SEAT

■ FRONT SEAT

RHD Models

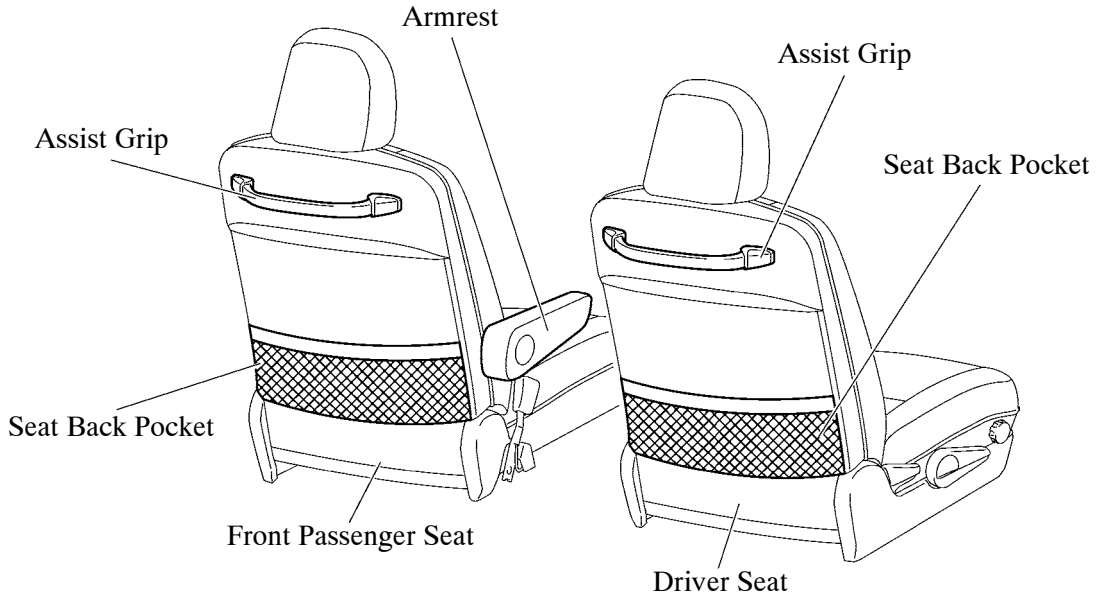
- On RHD models, a seat back pocket has been added for the driver seat, and an armrest has been added for the front passenger seat. In addition, an assist grip has been provided for the seat back of the driver and front passenger seats on all models to improve the ease of use.
- The forward tilt angle of the front passenger seat has been increased from 14° to 40° to improve the ease of getting in and out of the rear passenger seat.
